# Access Compliance Report

## Public Rights-of-Way

### (Curb Ramps)

Intersection ID: 19674	Main Street: BARCLAY_DOWNS_DR	Cross Street: MORRISON_BV	Location:	SE
ADA ID: 83F9D1255838	Ramp Type: Perp	Initial Pass/Fail: Fail	Overall Compliance: No	Severity Score: 25
Codes/Mitigation Info/Possible Solution		Field Measurements/Component Compliance

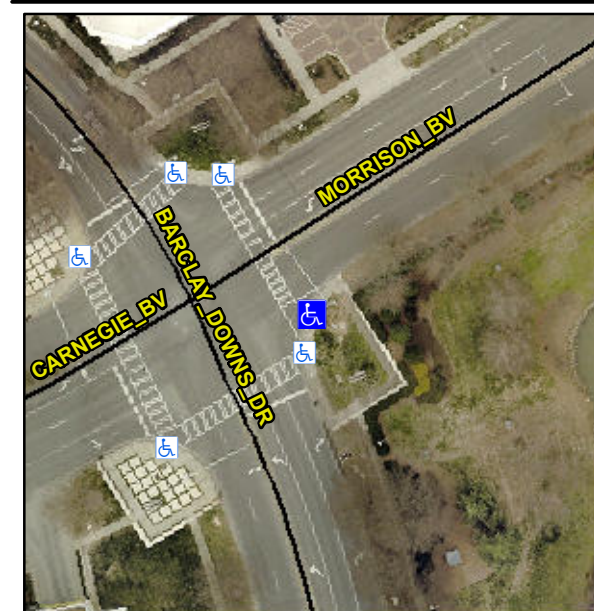
**Not Found, R304.2.2**

Compliance	Description	Data	Compliance	Description	Data
N/A	Ramp Length (in)	58.0	No	Ramp Slope (%)	12.8
Yes	Ramp Width (in)	48.0	Yes	Ramp XSlope (%)	1.9
N/A	Flare Type LT	N/A	N/A	Flare Type RT	N/A
N/A	Flare Slope LT (%)	N/A	N/A	Flare Slope RT (%)	N/A
N/A	Flare Traversable LT?	N/A	N/A	Flare Traversable RT?	N/A
N/A	Landing Length (in)	N/A	N/A	DWS Provided?	N/A
N/A	Landing Width (in)	N/A	N/A	DWS Contrast?	N/A
N/A	Landing Slope (%)	N/A	N/A	DWS Length (in)	N/A
N/A	Landing X Slope (%)	N/A	N/A	DWS Full Width?	N/A
N/A	Landing Curb? (Y/N)	N/A	N/A	DWS Offset (in)	N/A
N/A	Shared Landing?	N/A			
N/A	Gutter Ponding?	N/A	N/A	Gutter Slope (%)	N/A
N/A	Gutter Lip Ht (in)	N/A	N/A	Gutter X Slope (%)	N/A
N/A	Painted X Walk1?	Yes	N/A	Painted X Walk2?	N/A
	X Walk 1 Direction	To NW		X Walk 2 Direction	N/A
N/A	X Walk 1 Width (in)	84.0	N/A	X Walk 2 Width (in)	N/A
	X Walk 1 Slope (%)	2.0		X Walk 2 Slope (%)	N/A
	X Walk 1 X Slope (%)	3.1		X Walk 2 X Slope (%)	N/A

**Remove & Replace Entire Ramp.**
